UNITED STATES PATENT AND TRADEMARK OFFICE

APPLICATION NO.	FILING DATE	FIRST NAMED INVENTOR	ATTORNEY DOCKET NO.	CONFIRMATION NO.
10/076,813	02/15/2002	Reinaldo Mario Machado	06206 USA	2044
23543	7590	01/25/2005	EXAMINER	
AIR PRODUCTS AND CHEMICALS, INC. PATENT DEPARTMENT 7201 HAMILTON BOULEVARD ALLENTEWON, PA 181951501			PUTTLITZ, KARL J	
		ART UNIT	PAPER NUMBER	1621

Office Action Summary	Application No.	Applicant(s)	
	10/076,813	MACHADO ET AL.	
	Examiner	Art Unit	
	Karl J. Puttitz	1621

Ohta teaches a reaction apparatus, which is illustrated, for example in figure 1.:

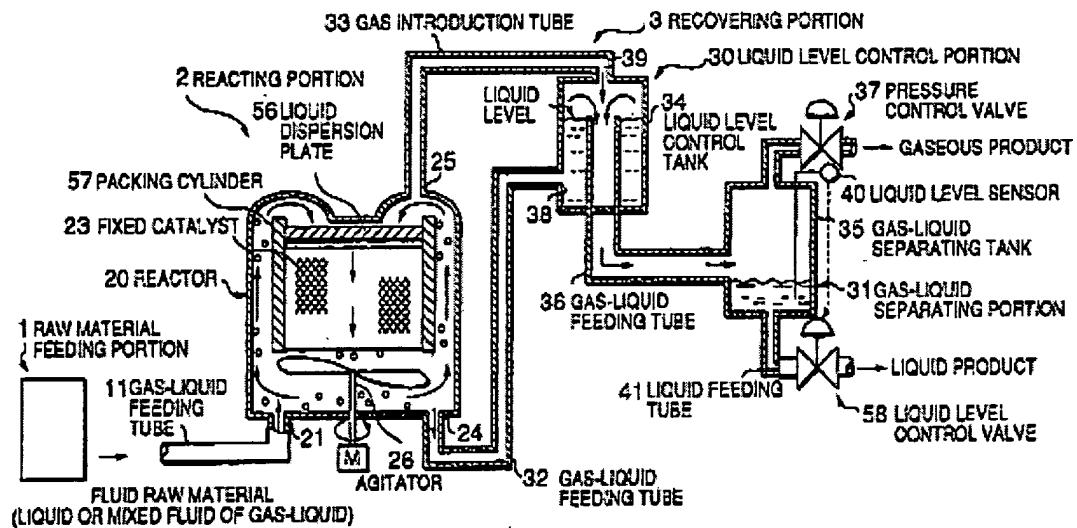
Ohta teaches at the description bridging columns 5 and 6 that As the raw material feeding portion 1 for feeding a fluid raw material, as far as it has a function of continuously feeding a liquid raw material or a mixed raw material of a gas and a liquid, there is no special limitation. For example, there is exemplified a raw material feeding portion which has a liquid raw material feeding portion and a gas raw material feeding portion and which is capable of switching the fluid to be fed. By structuring in this manner, a fluid raw material to be fed to the next

reacting portion 2 can be made into three kinds of a gas, a liquid and a gas-liquid mixture.

Further, as a gas raw material fed from the gas raw material feeding portion, for example, a reaction gas such as a hydrogen or inert gas and the like whose pressure is increased to a reaction pressure by a compressor, a bomb, etc. and whose flow rate is controlled by a flow meter, etc. can be exemplified.

The difference between the process set forth in Ohta and the process covered by the rejected claims is that Ohta does not specifically teach those nitroaromatic compounds set forth in the claims. However, one of ordinary skill would have been motivated to modify the disclosure of Ohta to include hydrogenation of the specifically claimed nitroaromatic compounds since Ohta teaches that the disclosed apparatus is suitable for hydrogenation reactions, and those of ordinary skill would necessarily include hydrogenation of the claimed nitroaromatic compounds.

Therefore, the rejected claims are *prima facie* obvious in view of Ohta since the reference teaches the claimed process with a reasonable expectation of success.

Fig. 9

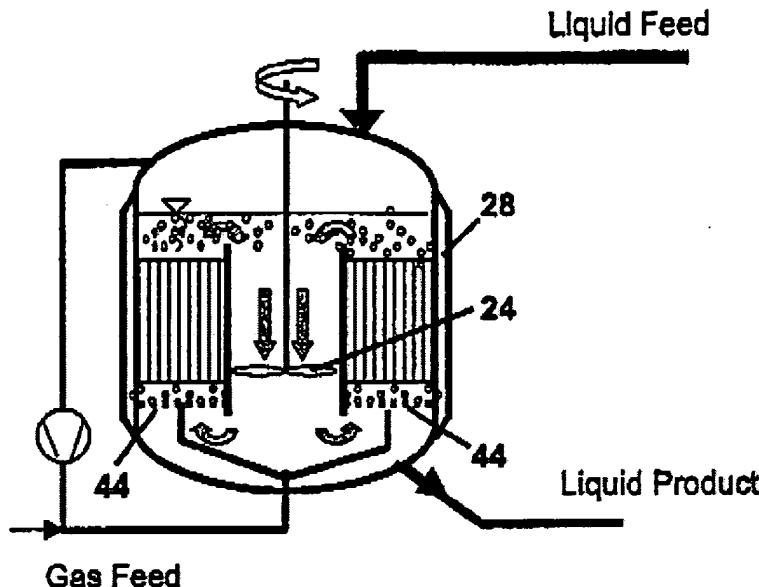
Boger teaches a reaction system ,as illustrated in Figure 9:

Boger teaches that the reactor is suitable for hydrogenation. See, for example paragraph 0048.

The difference between the process set forth in Boger and the process covered by the rejected claims is that Boger does not specifically teach those nitroaromatic compounds set forth in the claims. However, one of ordinary skill would have been motivated to modify the disclosure of Boger to include hydrogenation of the specifically claimed nitroaromatic compounds since Boger teaches that the disclosed apparatus is suitable for hydrogenation reactions, and those of ordinary skill would necessarily include hydrogenation of the claimed nitroaromatic compounds.

Therefore, the rejected claims are *prima facie* obvious in view of Boger since the reference teaches the claimed process with a reasonable expectation of success.

Fig. 1

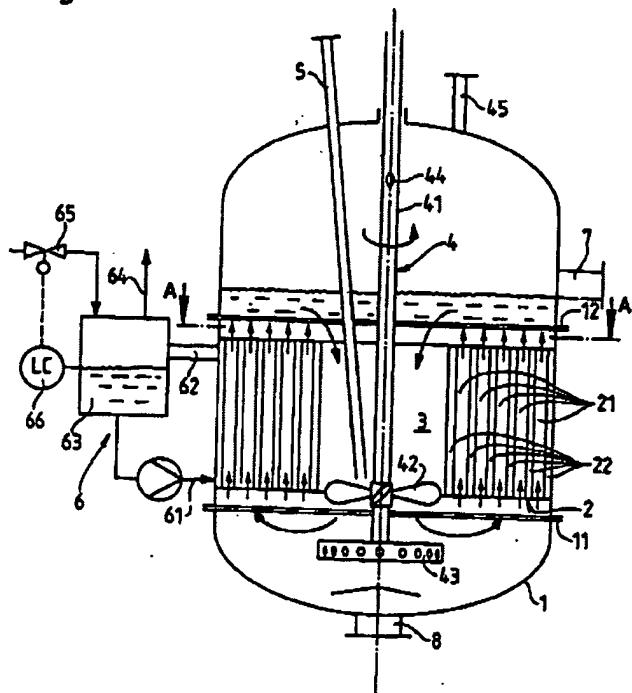
Witt teaches a reaction system illustrated, for example, in Figure 1:

Witt teaches that the sludge phase reactor according to the invention and having a gassing agitator is particularly suitable for performing the sludge phase

hydrogenation of aromatic nitro compounds, particularly preferably for the hydrogenation of dinitrotoluenes with the production of the corresponding diamines. See column 2, lines 30-35.

The difference between Witt and the claimed inventions is that Witt does not teach the invention with particularity so as to amount to anticipation (See M.P.E.P. § 2131: "[t]he identical invention must be shown in as complete detail as is contained in the ... claim." *Richardson v. Suzuki Motor Co.*, 868 F.2d 1226, 1236, 9 USPQ2d 1913, 1920 (Fed. Cir. 1989). The elements must be arranged as required by the claim, but this is not an *ipsissimis verbis* test, i.e., identity of terminology is not required. *In re Bond*, 910 F.2d 831, 15 USPQ2d 1566 (Fed. Cir. 1990).). However, based on the above, Witt teaches the elements of the claimed invention with sufficient guidance, particularity, and with a reasonable expectation of success, that the invention would be *prima facie* obvious to one of ordinary skill (the prior art reference teaches or suggests all the claim limitations with a reasonable expectation of success. See M.P.E.P. § 2143).
